**CCPS RFP#24-15 – NORTH EAST MIDDLE/HIGH SCHOOL REPLACEMENT PROJECT**

**ADDENDUM #5**

**This addendum is to address Bid RFIS and contract drawings, and specification modifications as noted below.** Proposers and related parties will be responsible for reading and understanding all documents, the scope of work, addenda and all related solicitation documents issued. These documents will become attached to and part of the solicitation and award of bid contract.

ITEM No. 2 **CONTRACT DRAWINGS AND SPECIFICATIONS- Changes and Clarifications dated 04/02/2024.**

| SHEET NO.: C-6 | MAJOR SITE PLAN (EAST) |

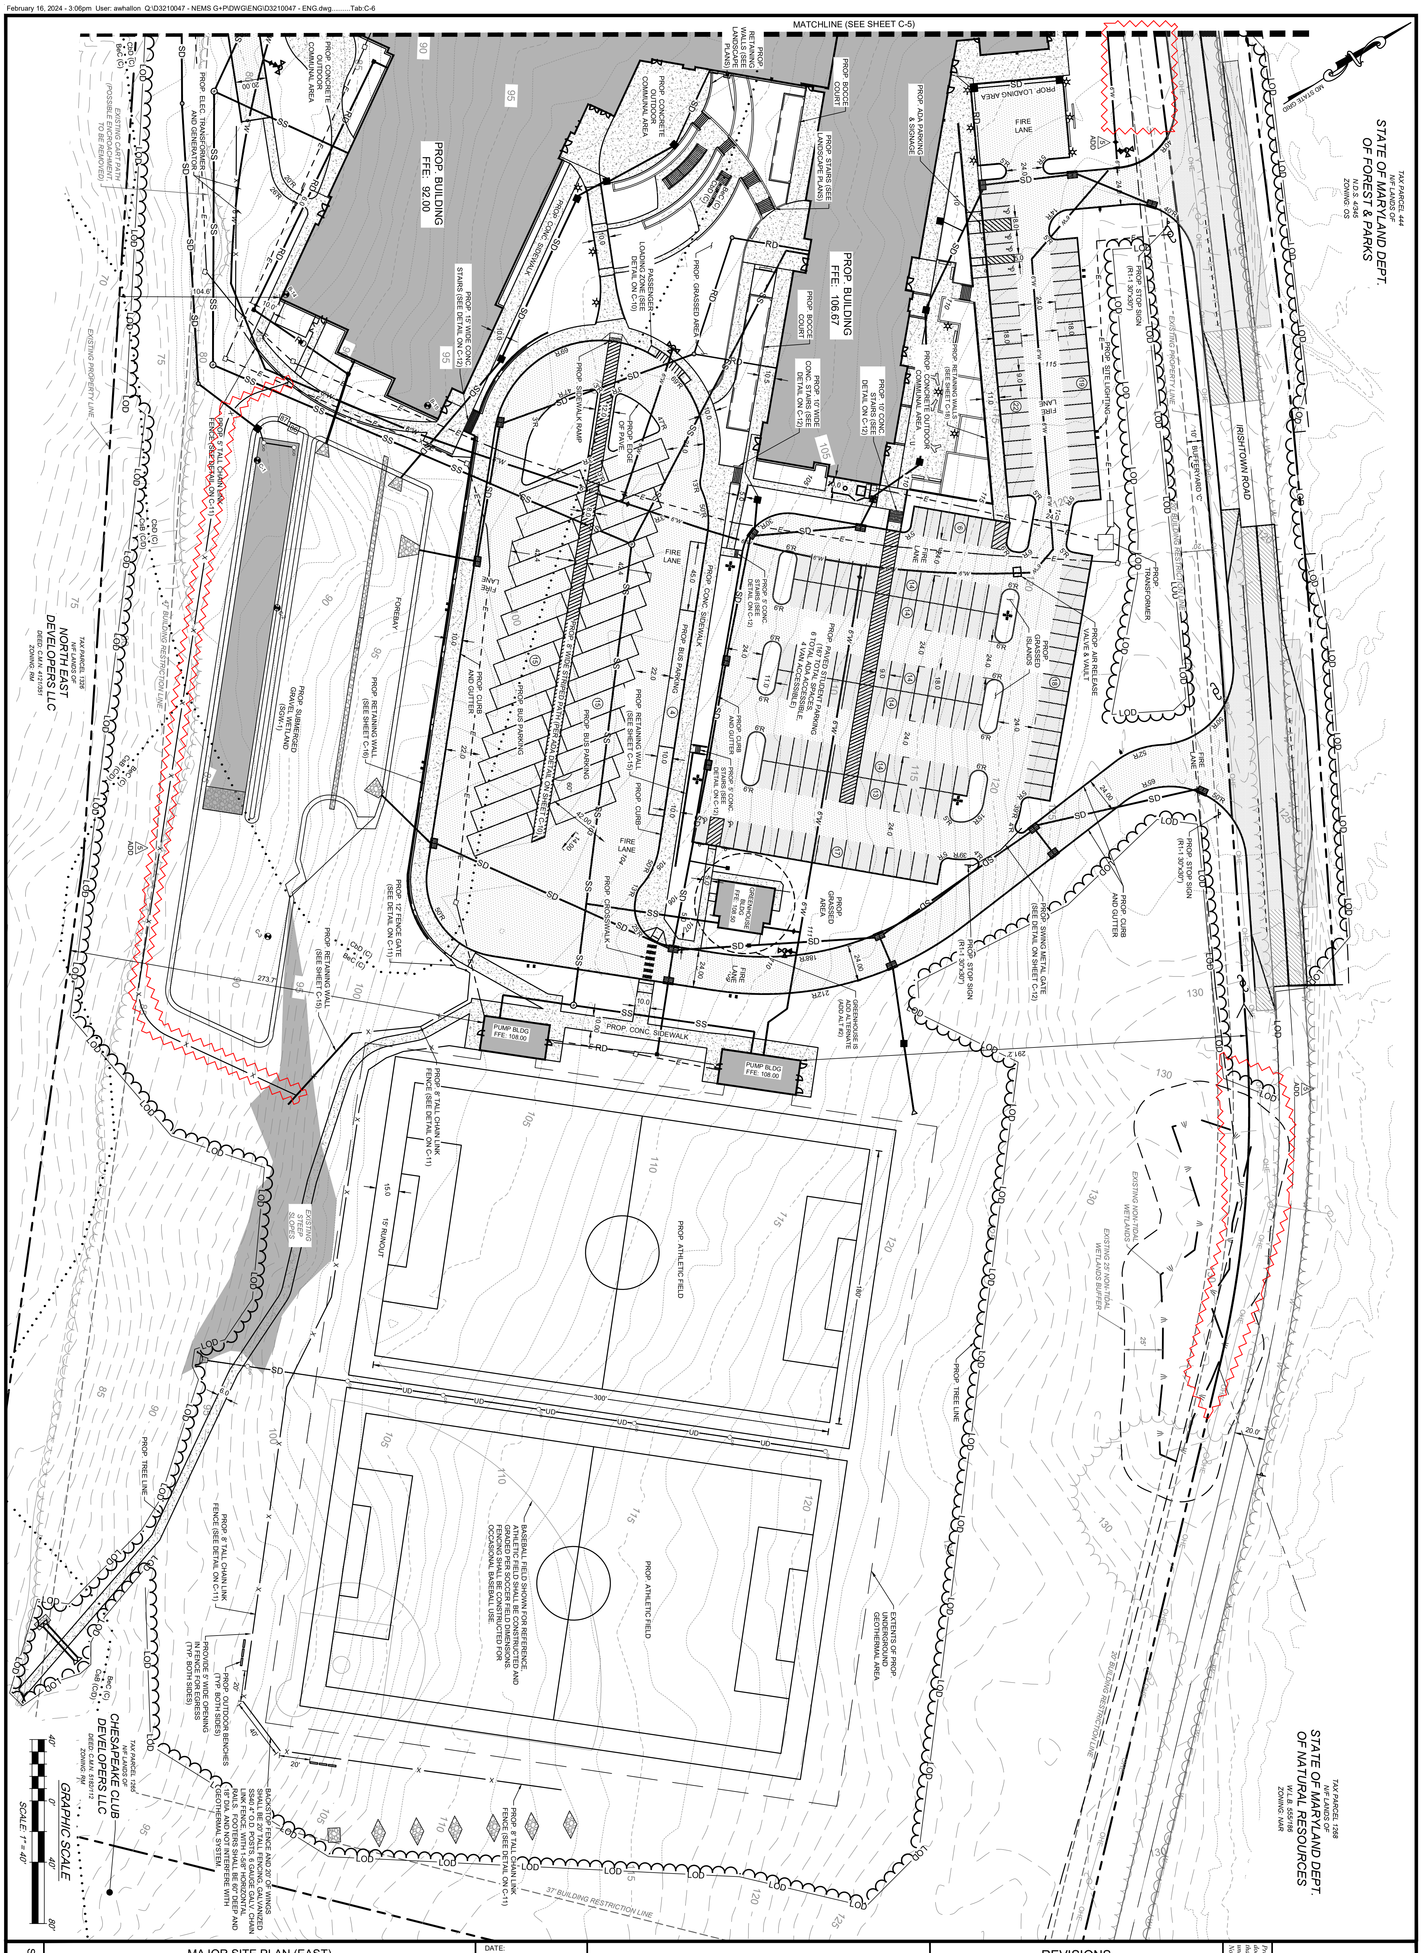
| CCPS RFP#24-15 – NORTH EAST MIDDLE/HIGH SCHOOL REPLACEMENT | | | |
|---|---|---|---|
| 429 | 3/20/2024 | See Sheet C-6, please confirm that the dark grey area is the only area of the submerged gravel wetland getting stone and planting material. Are all other areas of the submerged gravel wetland to be assumed topsoil and seeded areas? | Please bid the stormwater features from their specific design sheets. Sheet F-ESD-25 defines the media area required. The rest of the SGW bottom is 4" topsoil, seed, and mulch. |

| DATE: | NOV. 2022 |

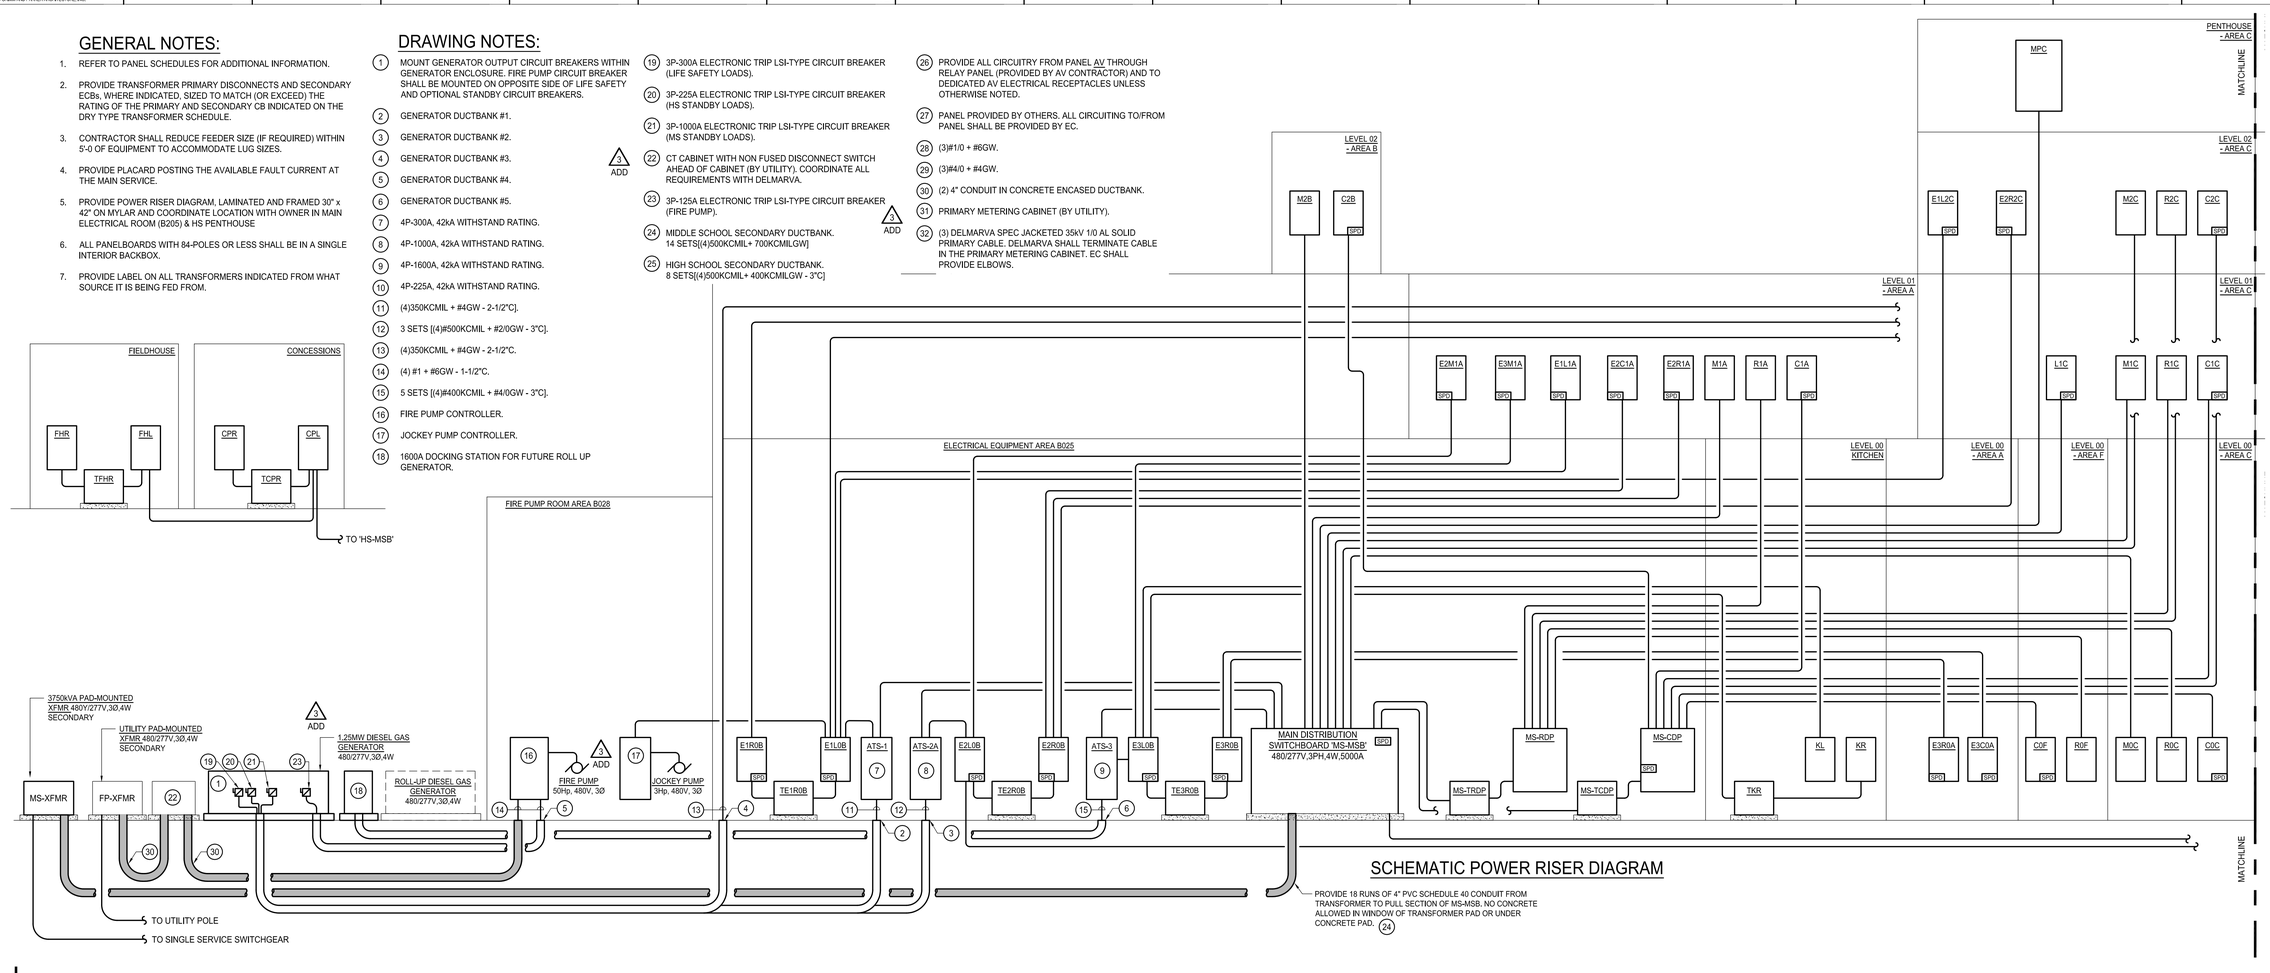
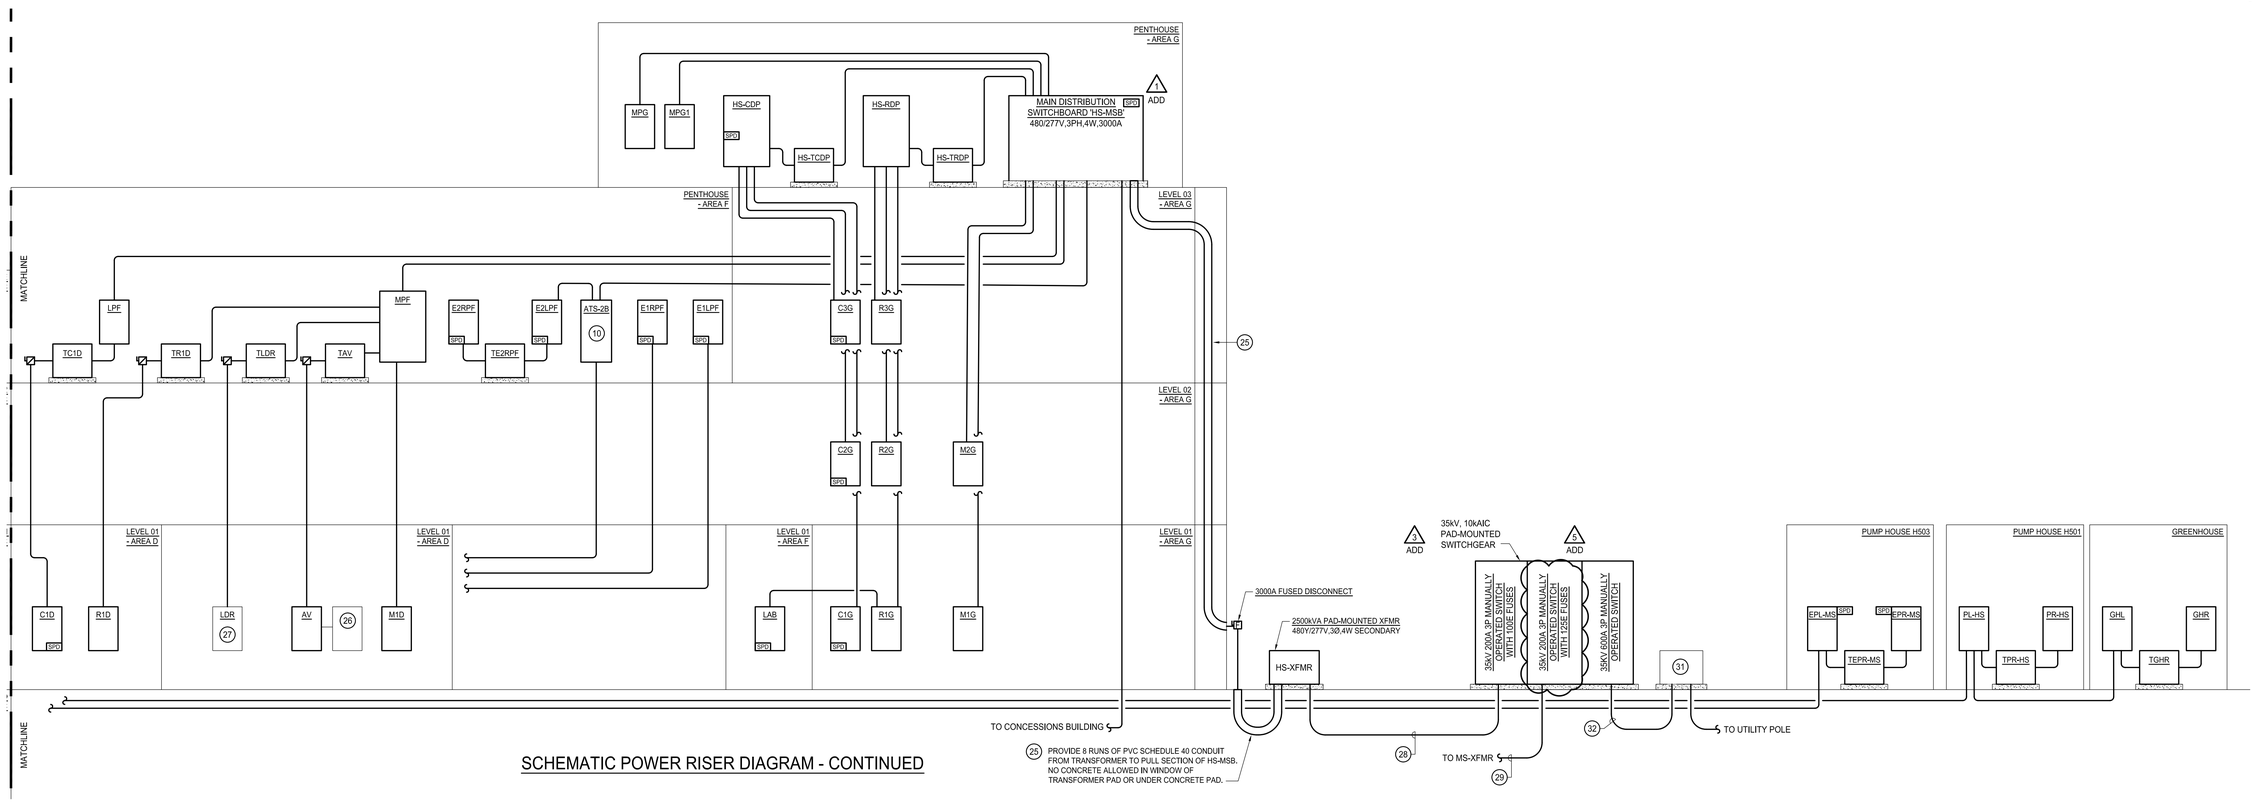
| CCPS RFP#24-15 – NORTH EAST MIDDLE/HIGH SCHOOL REPLACEMENT | | | |
|---|---|---|---|
| 1 | 2/29/2024 | Per drawing E601, HS-MSB is identified as 4000A on the riser diagram, but 3000A in the schedule (drawing E708). Please clarify. | HS-MSB is 3000A. Riser will be updated to reflect |
